REGIONAL REVIEW FINDING

ARC REVIEW CODE: R2108091

Name of Proposal: Waldon Park DRI #3257Submitting Local Government: Clayton CountyReview Type: DRIDate Opened: August 9, 2021

P:\Projects\Rockhaven Homes\136.015 Tara Blvd. aka Poston Road\PLANNING\DRI\CP101 DRI.dwg, jlee, Mon, Jul 12, 2021 - 4:57pm Waldon Park | DRI #3257 | Transportation Analysis

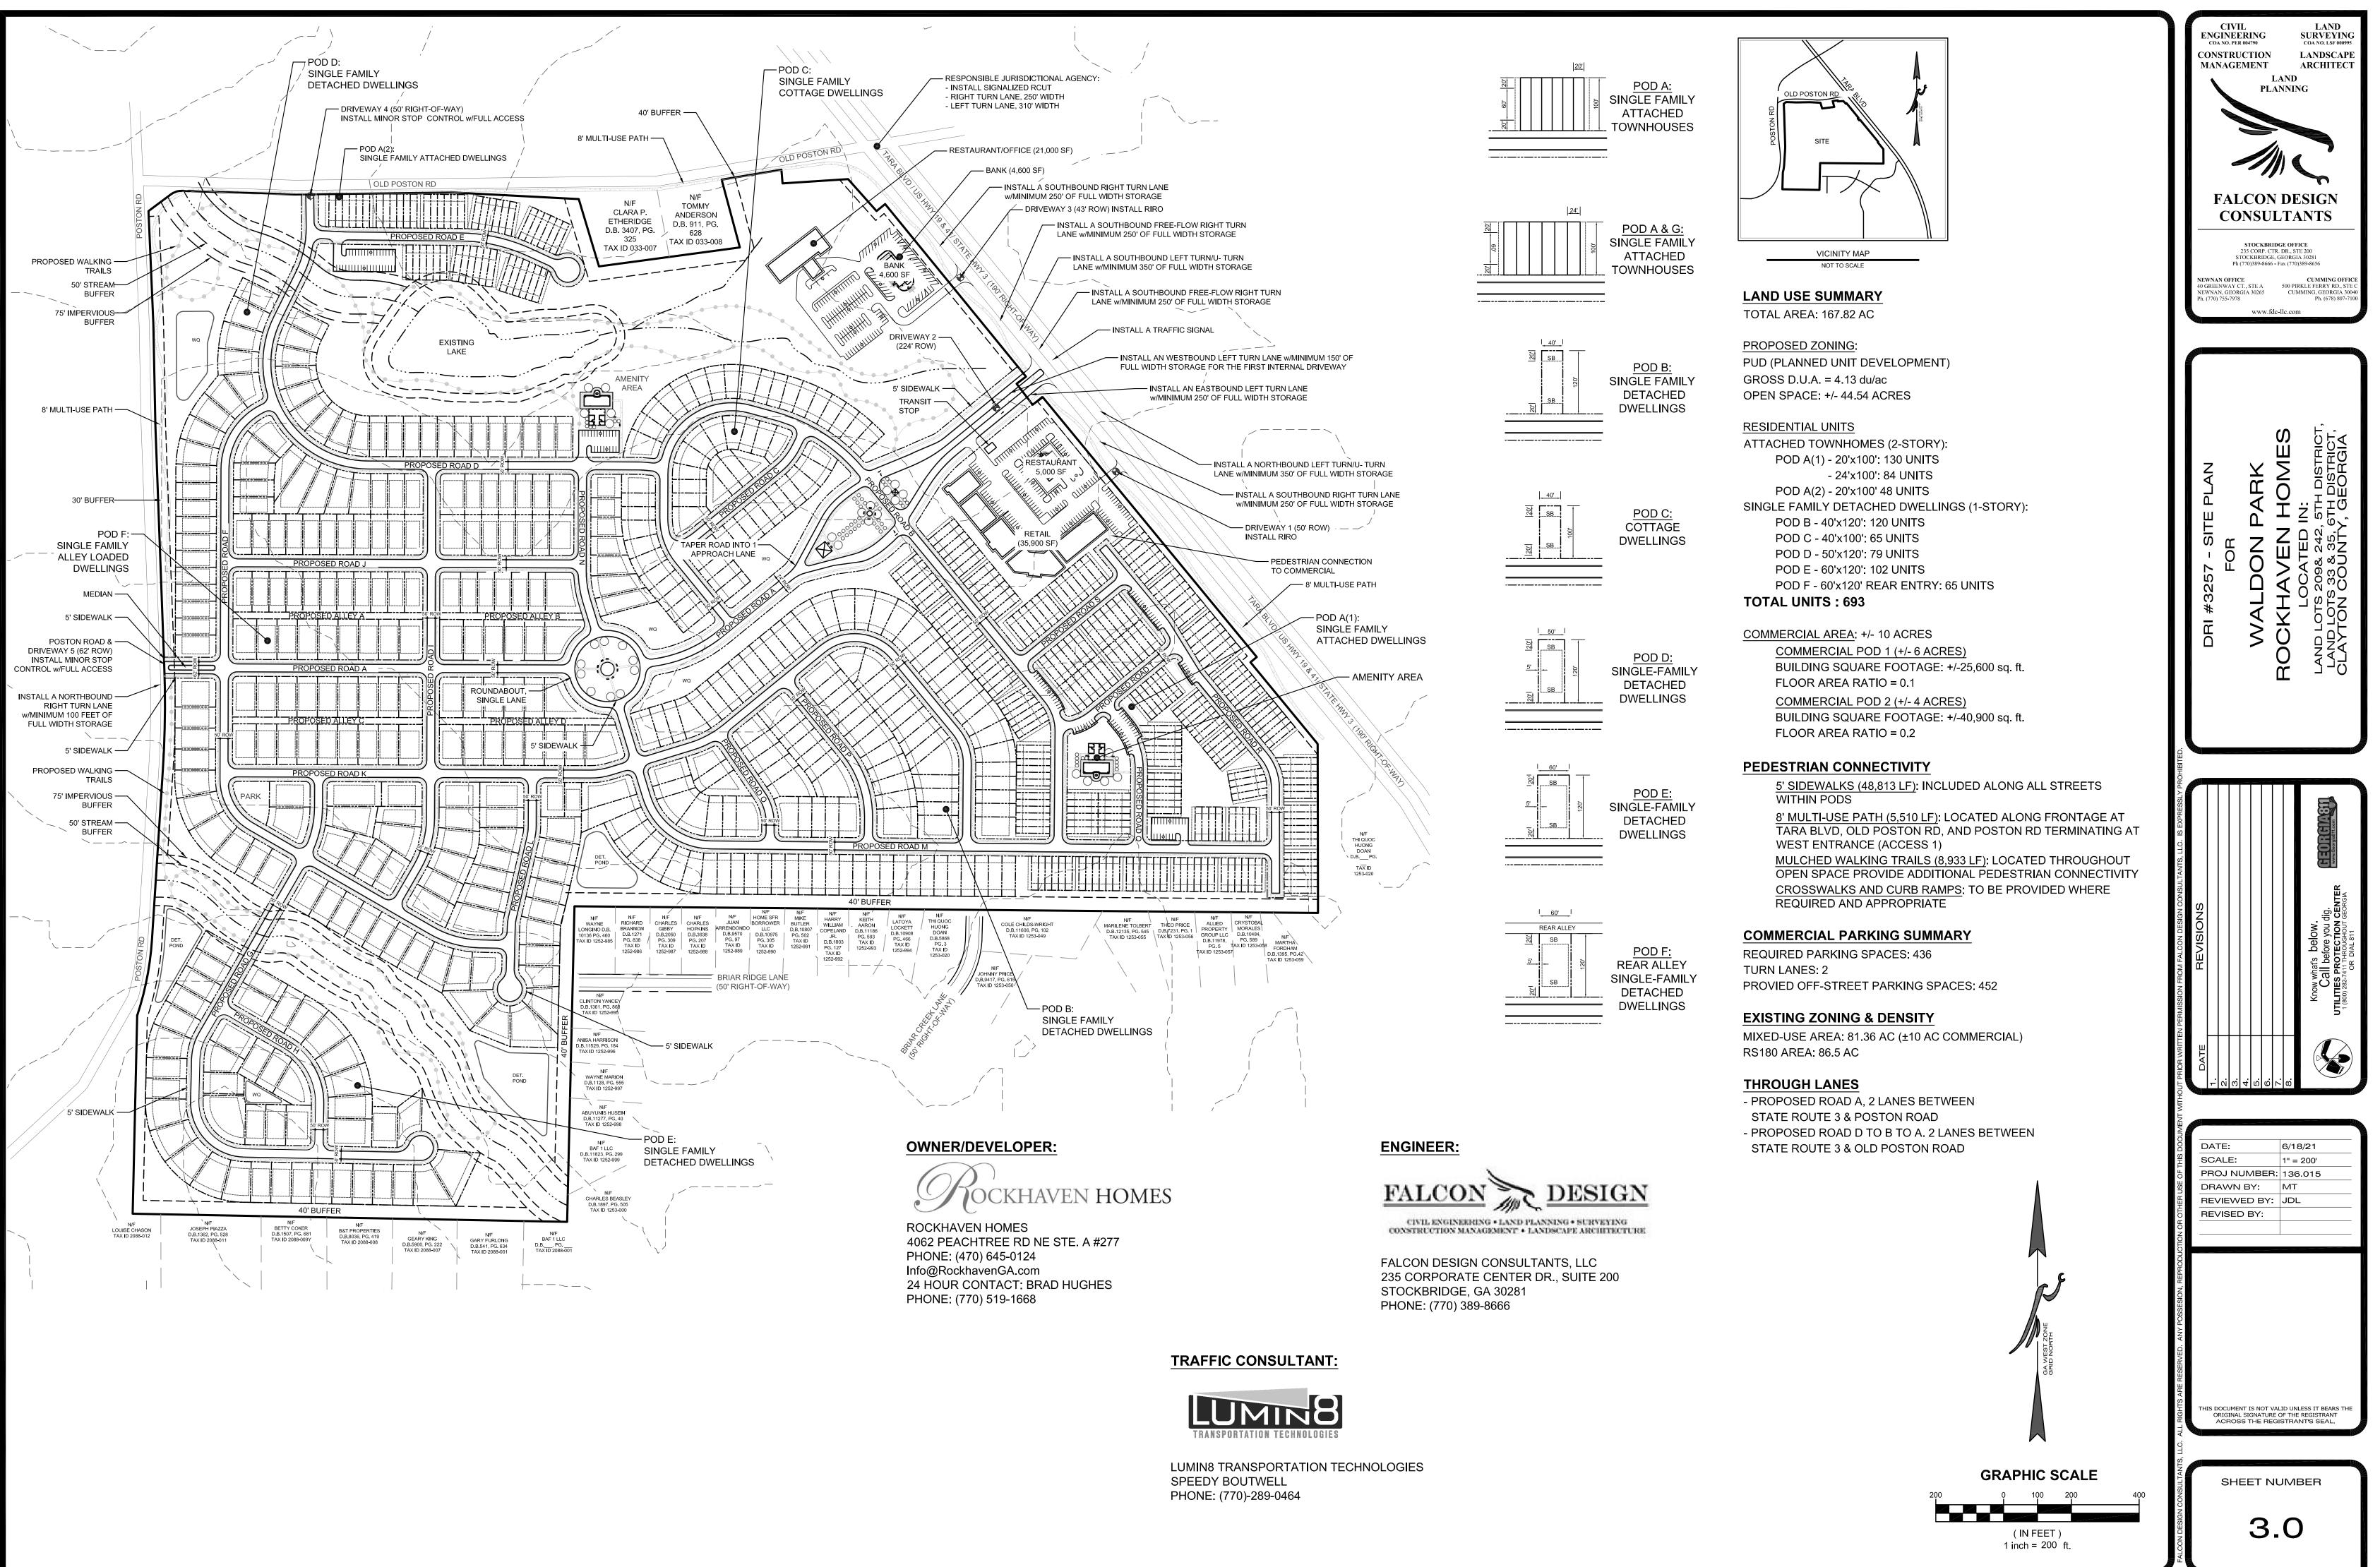
Additional comments from ARC's Natural Resources Group are attached. They indicate that the DRI site plan shows a lake and stream in the northern part of the property and a stream in the southwest part of the property. The 50-foot undisturbed buffer and additional 25-foot impervious surface setback (total of 75 feet) required under the Clayton County Stream Buffer Ordinance are shown along both streams, but the applicable 25-foot State Erosion and Sedimentation Act buffer is not clearly identified for either stream. The only development activities shown in the stream buffers are internal street and sidewalk crossings (Road D and Road G), but this activity may require County and/or State variances.

The USGS coverage for the project area shows an existing pond but no streams on the project property. Both the pond and a stream running through it are shown on the submitted site plan. In addition, a second stream crosses the southwest portion of the project property. The 50-foot undisturbed buffer and 25-foot impervious surface setback required under Clayton County Stream Buffer Ordinance are shown along both streams. The Georgia 25-foot State Erosion and Sedimentation Act buffer also applies to both streams but is not shown on either stream on the plans. The only development activity shown within the stream buffers on both streams are driveway and sidewalk crossings, which may require variances. Any unmapped streams may also be subject to the County Buffer Ordinance and all unmapped waters of the state may be subject to the 25-foot State Erosion and Sedimentation Act Buffer.
